## COMMENT ON THE INFORMAL DOCUMENT GRSP-69-26

### Comments on the Informal document GRSP-69-18

#### Proposal of Supplement 2 to the 06 series of amendments to UN Regulation No. 22 (Protective helmets)

*Annex 8 - New figure 1d, amend to read:*

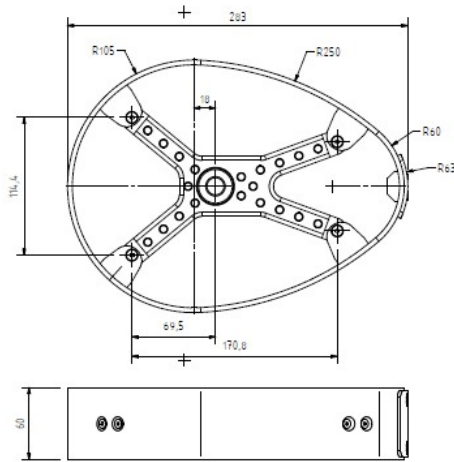
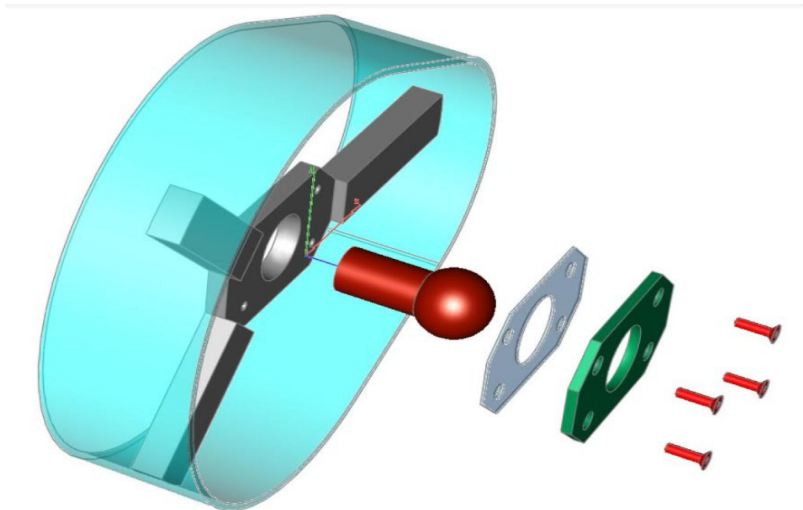
**Comment:** This simulator does not reproduce the actual behaviour that the accessory would have if fitted to a helmet. The helmet can rotate around the headform during the test. This simulator only gives one degree of freedom: rotation through the fixation axe

New simulator proposal with three degrees of freedom could better represent what could happen in a real test.

The new proposed system could be calibrated as it is the Hybrid III femur-hip joint.

Test has been designed to be in line with the actual procedures used in the Regulation 22: the test apparatus used to assess the helmet donot foresee any simulation for the neck (such as a similar ball joints). This decision rely historically in the need to have a conservative, repeatable and cost effective test.

The helmet simulator is conservative respect the actual behavior: in the market there are helmet with close fit which has very limited movement as well as other kind where movement around the head may be more. Helmet simulator stays representative of the worst case scenario. The test campaign has demonstrated a direct correlation between pass performance between the test of the accessory when fitted on the helmet and when on the proposed simulator.

Figure 1

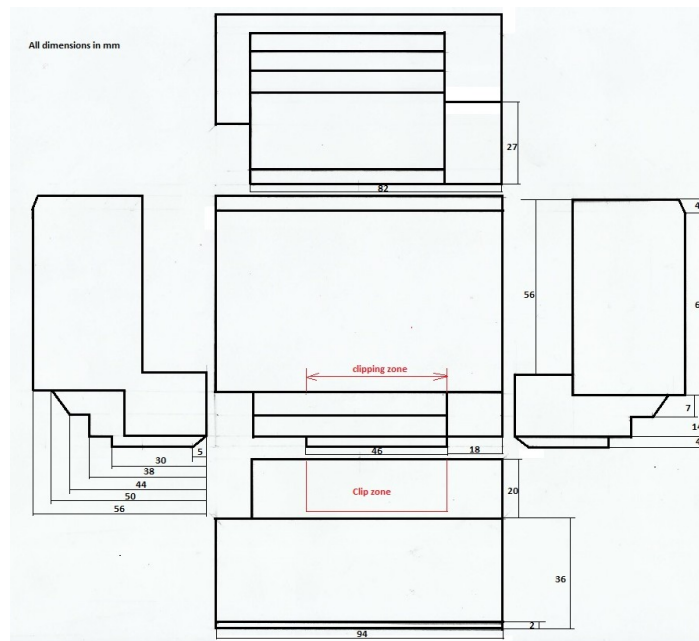
**Comment: [Volume was only indicated in the document as a reference for defining the building possibilities, no need to introduce it in the text]**

Figure 2

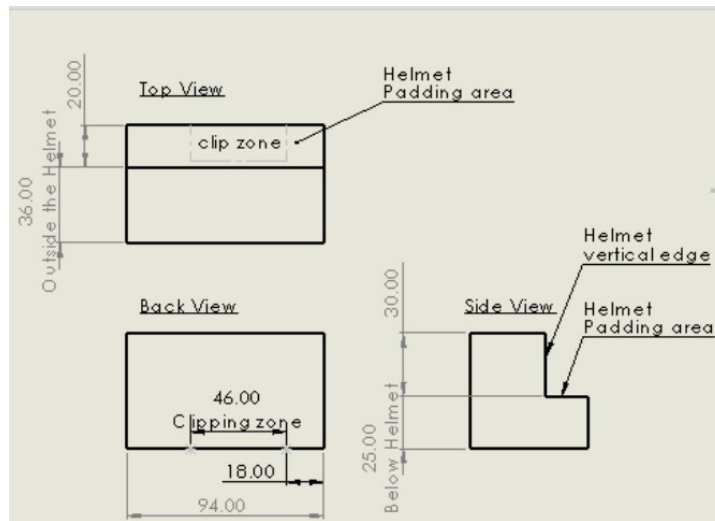
Comment: [Volume was only indicated in the document as a reference for defining the building possibilities, no need to introduce it in the text]

Figure 3

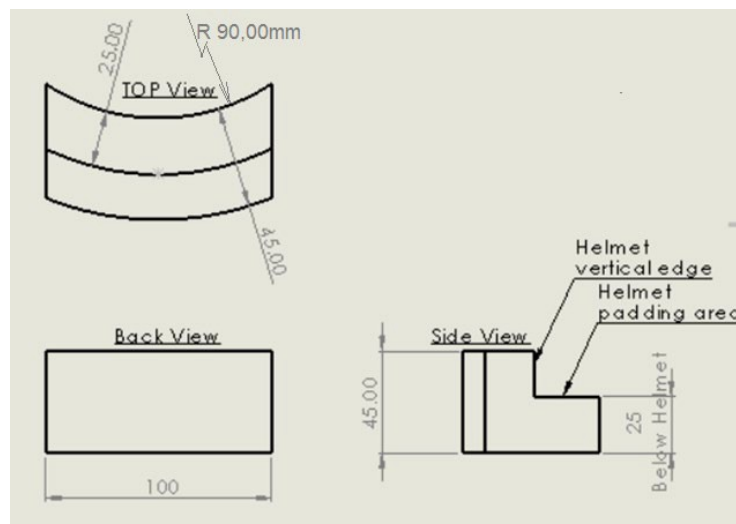
Comment: [Volume was only indicated in the document as a reference for defining the building possibilities, no need to introduce it in the text]

Example of curve

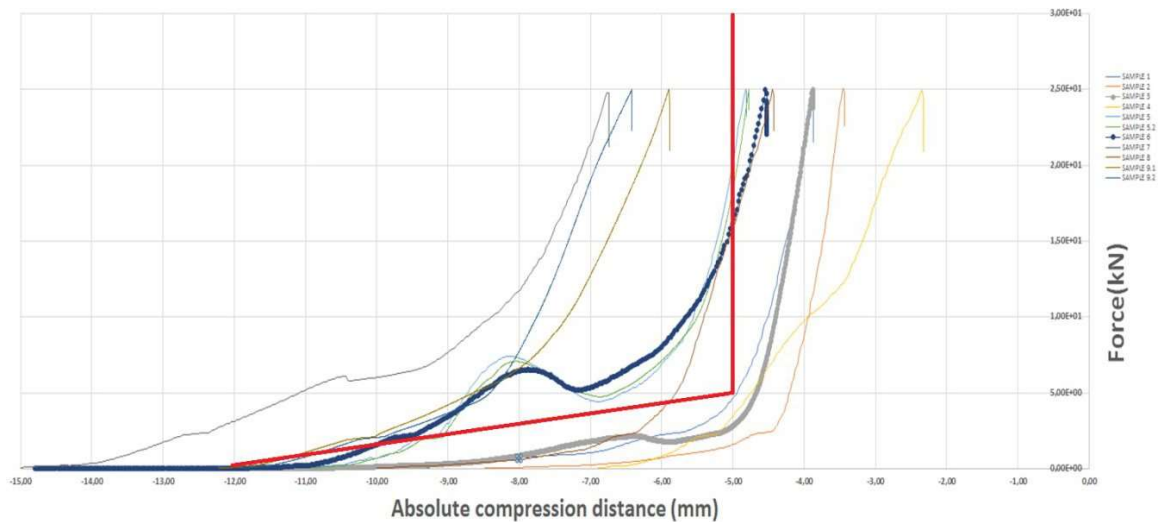
Comment: Can be done at 200 mm/min, no changes on the curves are expected and it is much faster for testing purposes. Test until 25KN. Better define a corridor than a single point. Corridor to be determined after intensive testing for evaluating the effects on test results.

**Comment:** More tests are necessary. Industry does not have any clear input on the impact this might have on the helmet results. Only one or two helmets reported to be tested and no data from the conditions or geometry of the pockets or EPS or shell or even size tested.

The comment appears not to be feasible as the speed mentioned is too high: 200 mm/min would mean 1 mm in 0,3s and thus 8mm in 2,4s with the high probability to damage test equipment when free space is reduced to zero (in less than 1s).

Which is the rationale to choose 25kN? 1kN has been chosen to grant AISI 0 during the compression of the speaker to 8mm which is the height of the simulator.
